REMARKS/ARGUMENTS

In section 2 of the office action, the disclosure was objected to because of an informality regarding a typographical error. In response, the specification is being amended above to indicate that 10/099,372 is a continuation-in-part of 09/691,726. For the above reasons, Applicant requests reconsideration and withdrawal of the objection to the specification.

FIGURE 1

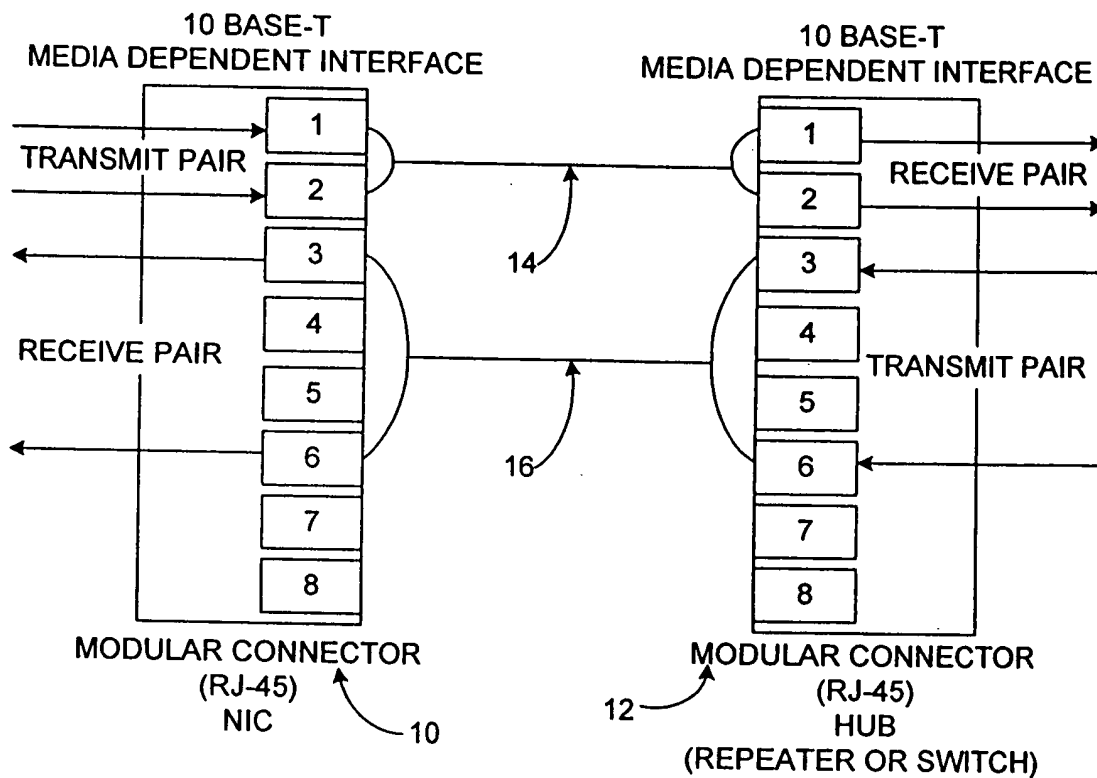
In sections 4-8, the drawings were objected to because of various informalities. In response, the specification is being amended above to add various reference characters shown in Figure 4. The elements, "defined timer", NLPs, IDLE, T_pulse, signal detector, and reset signal generator, are also being removed from the claims, in response to the drawing objections. No new matter is being added by the correction to the drawings and amendment to the specification. For the above reasons, Applicant requests

~~(BACKGROUND METHOD)~~
(prior art)
